Caithness-Moray Strategic Wider Works Needs Case Assessment

A report for Ofgem - REDACTED

18 March 2014

Figure 7 – Difference in assumed generation profile between SP and Ofgem scenarios

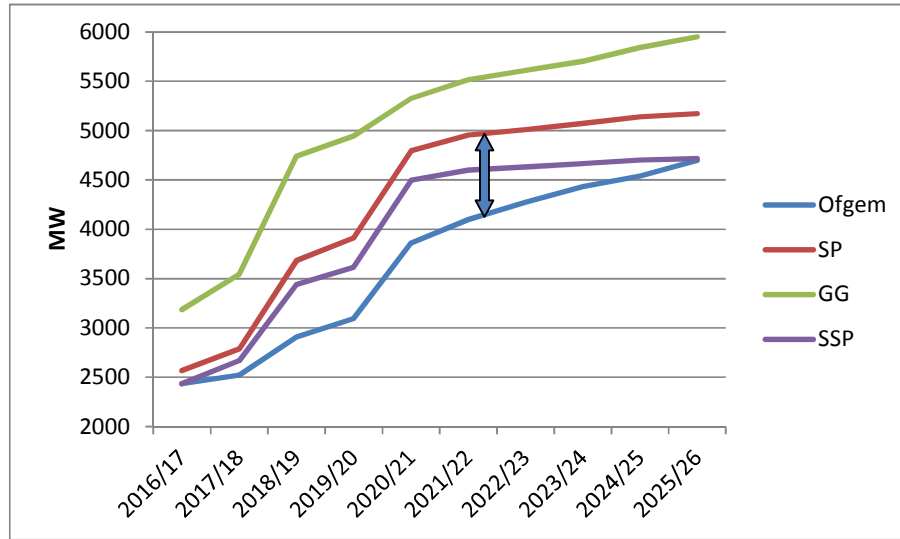
Figure 7 below illustrates that the “Ofgem” scenario does not just follow Slow Progression but represents a more realistic downside short term generation forecast.

Considering all the information provided DNV KEMA believes that the five generation scenarios considered by SHE Transmission and their consultants capture the reasonable range of the possibilities for the development of generation in the area considered.

Figure 8 - B0 capability compared with SQSS requirement

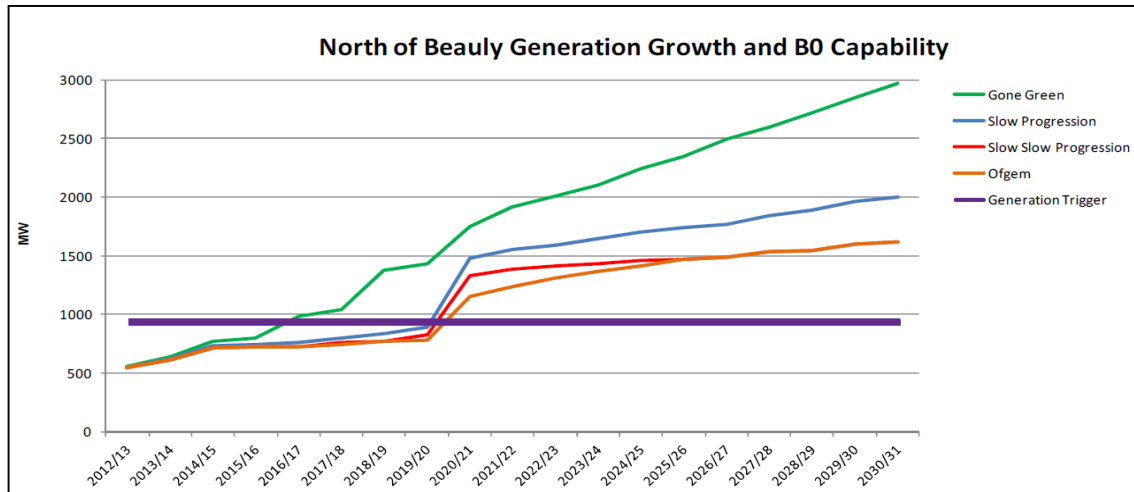
SHE Transmission studies indicate that by 2016/17 under the Gone Green generation scenario, by 2020/21 under SSP or by 2021/22 under “Delayed SSP”, the network does not comply with the criteria set out in Chapter 4 of the SQSS. The above SQSS assessment only indicates the need for the reinforcement, not the optimal timing for the reinforcement.

Based on the background of contracted generation it is clear from SHE Transmission’s assessment that without reinforcement the transmission system will be overloaded beyond its capacity and would breach the SQSS requirements. The Technical Needs Case contains simple calculations based on SQSS that provide the approximate level of generation that triggers the requirement to reinforce the existing network.

The approach taken by SHE Transmission is consistent with the SQSS planning criteria and it represents an adequate technical assessment of the existing capacity of the transmission network.

Figure 9 – Existing B1 boundary capability including existing works

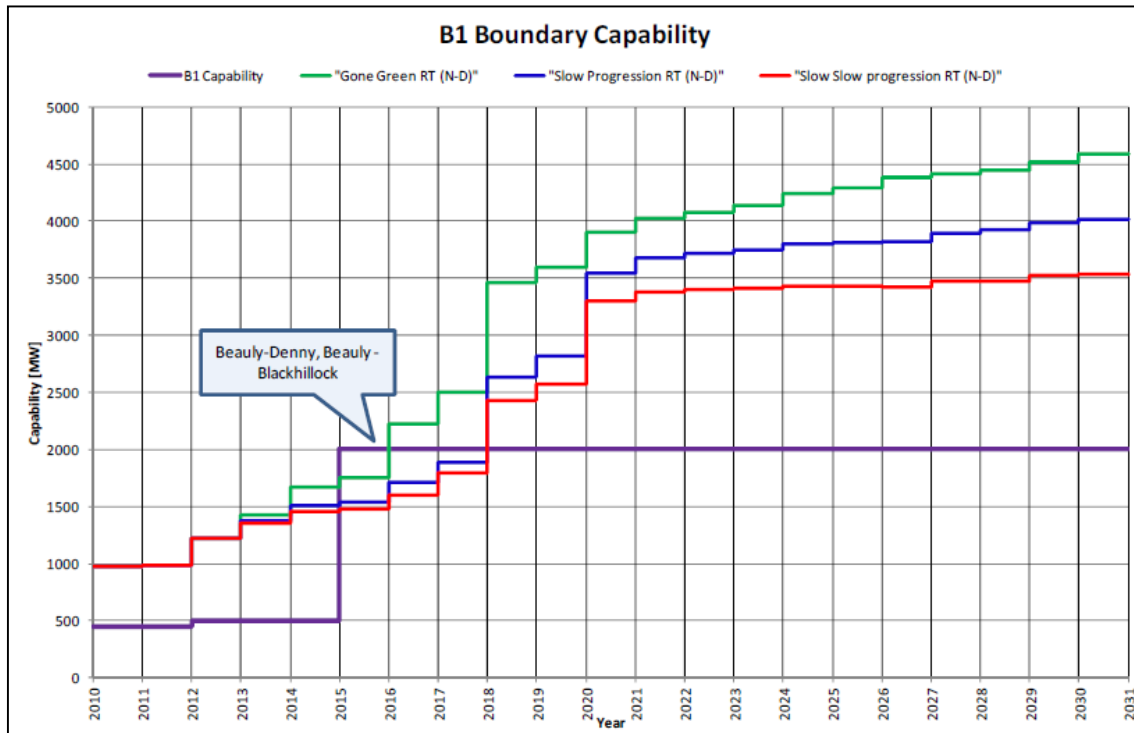
Figure 9 demonstrates that the SQSS required transfer levels across the B1 boundary are in excess of the actual B1 boundary capability by 2018 in all generation scenarios, indicating the need for reinforcement across this boundary.

Figure 11 – Reinforcement options between Beaulieu and Blackhilllock

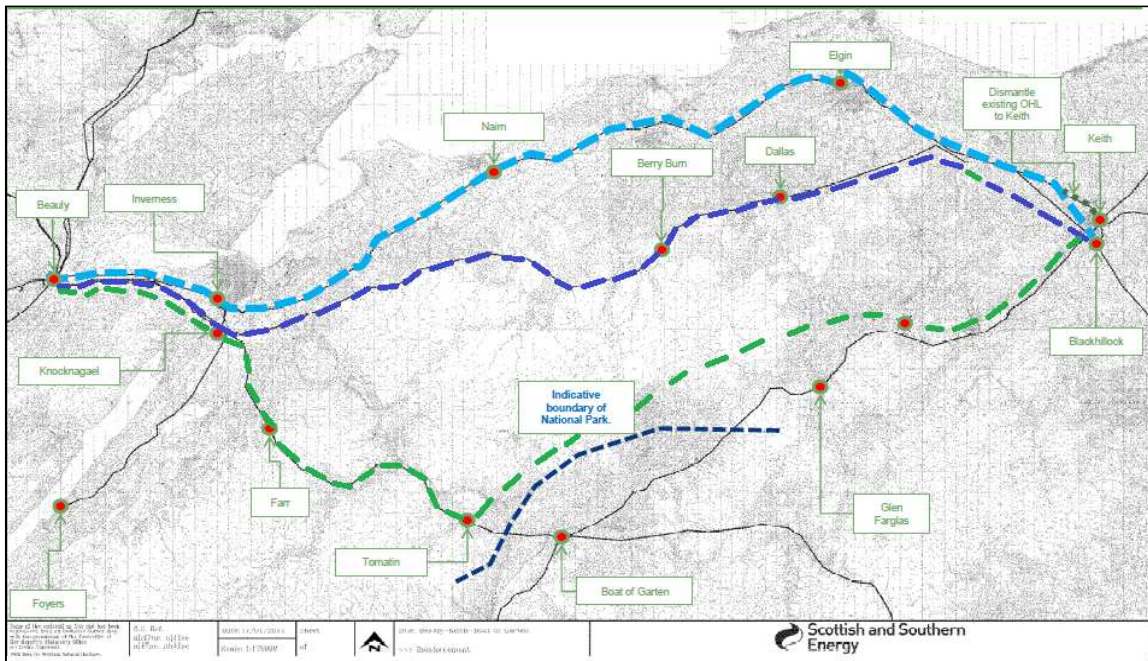
Based on the information provided, SHE Transmission conducted the optioneering process on the BB400 only at a high level, providing a limited level of detail. There is no scoring methodology applied, limited number of selection criteria provided and no weighting factors to remove subjectivity from the selection process. In our view there is only limited confidence in the cost estimate associated with the proposed BB400 reinforcement considering that the route is not fixed and that there is potential for a new substation along this route. In comparison with optioneering for reinforcement of the B0 boundary it is clear there are deficiencies in the options identification process for the reinforcement of B1 boundary.

Given the limitations of the optioneering process we consider that there is a realistic possibility for both scope and costs to change. We also consider that the optioneering process does not cover the adequate level of detail that would be expected at this stage of the project development. As such, it is not in line with the approach taken in the technical Needs Case e.g. no evidence is available to show how SHE Transmission has considered a number of key criteria associated with different reinforcement options or of the weighting factors applied. It is also unclear how SHE Transmission has estimated the potential cost for the BB400 works, when there is no clarity regarding the recommended OHL route or requirement for a new substation.

Figure 12 – Option comparison for anticipatory investment

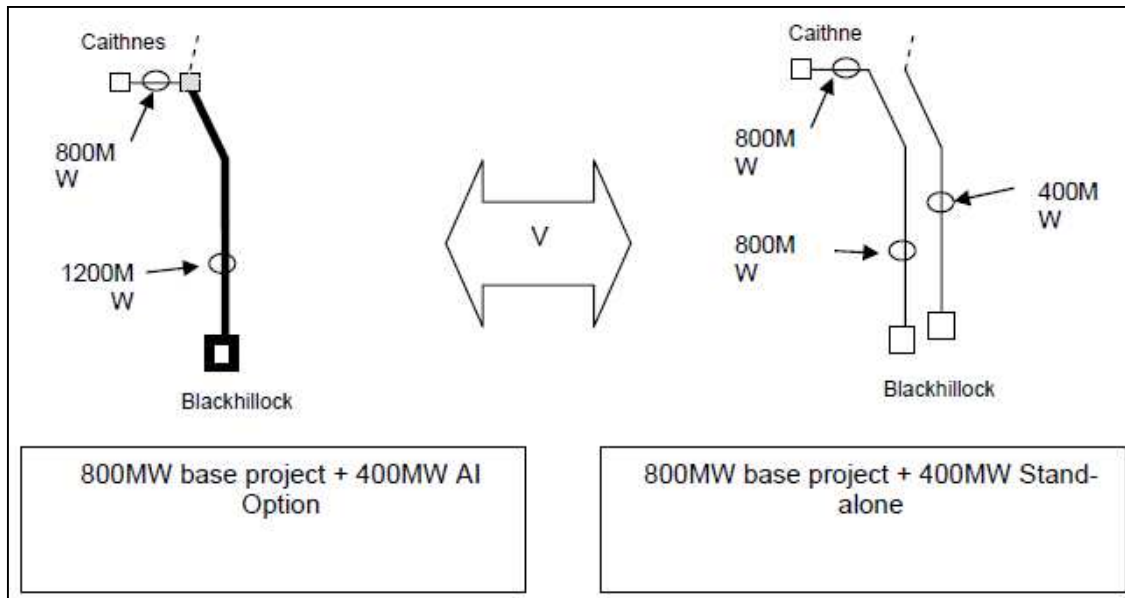
The options under consideration compare the £■■■m spend against £■■■m spend later. The further into the future the £■■■m spend, the less its Present Value is today. Given the time difference, there may be value to incur the option cost now and provide the level

⁷ Estimated cost for HVDC link with anticipatory investment of £■■■m does not correspond with total cost estimate for HVDC of £■■■m. It appears that costs in analysis of anticipatory investment hasn't been updated with most recent figure. In our opinion this omission does not have material effect on analysis provided

Figure 13 – Regret calculation

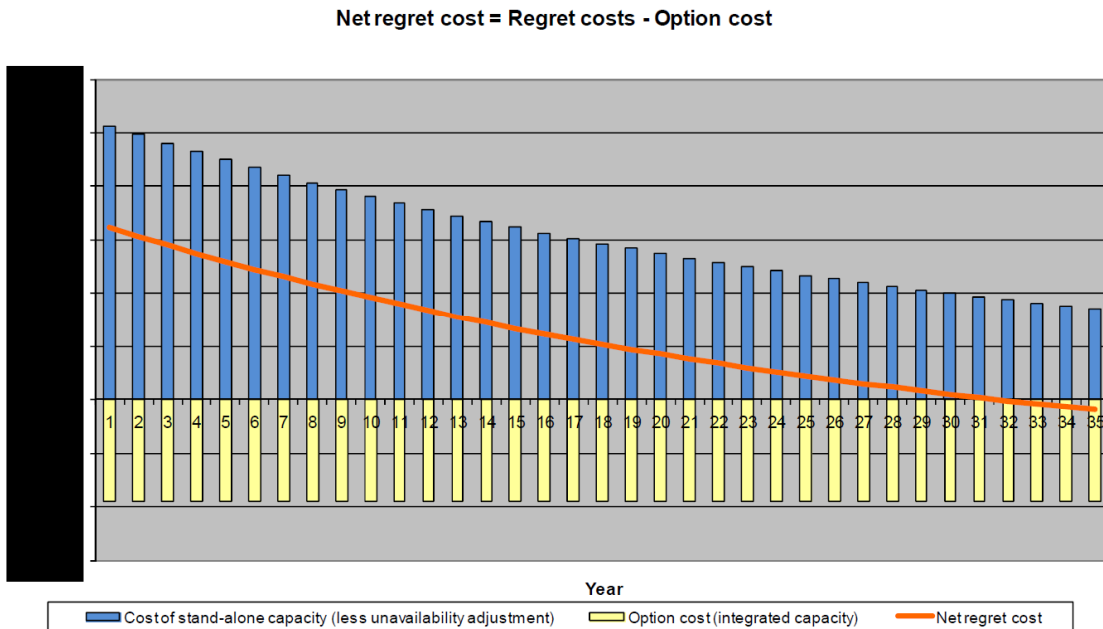
Figure 13 shows the results of a regret calculation at a discount rate of 6.25%. DNV KEMA concurs that SHE Transmission approach is reasonable, however, we consider that further clarifications need to be provided in Stage 2 about the estimated cost of the anticipatory investment.

Figure 14 – Initial and latest cost estimate for the options considered

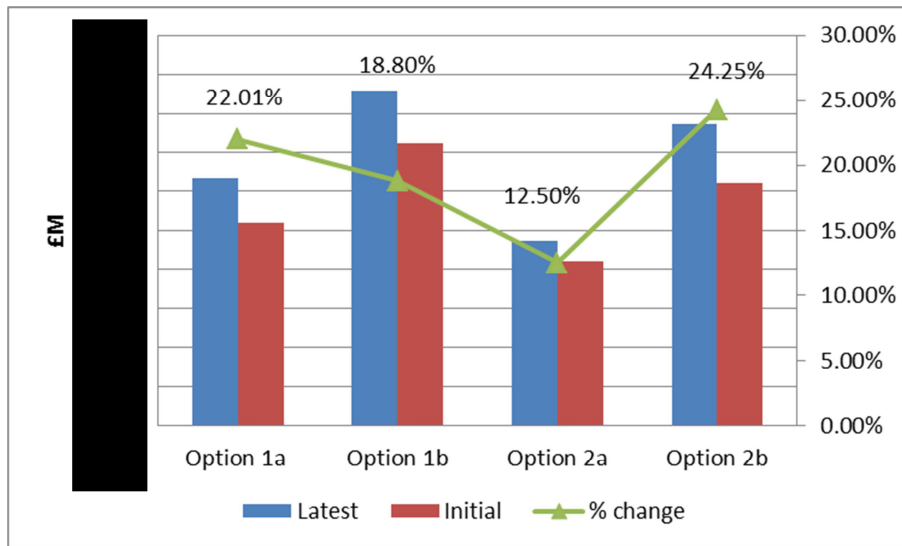
It is evident from Figure 14 that “cost creep” is a real risk with the cost estimate for each of the options considered increasing between 12.50%-24%. While cost increases for the HVDC elements are explained, with recent information reported from the tender returns, it is unclear what drives the increase in AC related cost. There is no indication of any recent AC projects that influenced increases in cost or any changes in the scope of work initially. In addition, aside from costs associated with Blackhillock substation,¹⁷ we have not received any feedback from SHE Transmission relating to a rationale for the cost increase relating to the AC options.
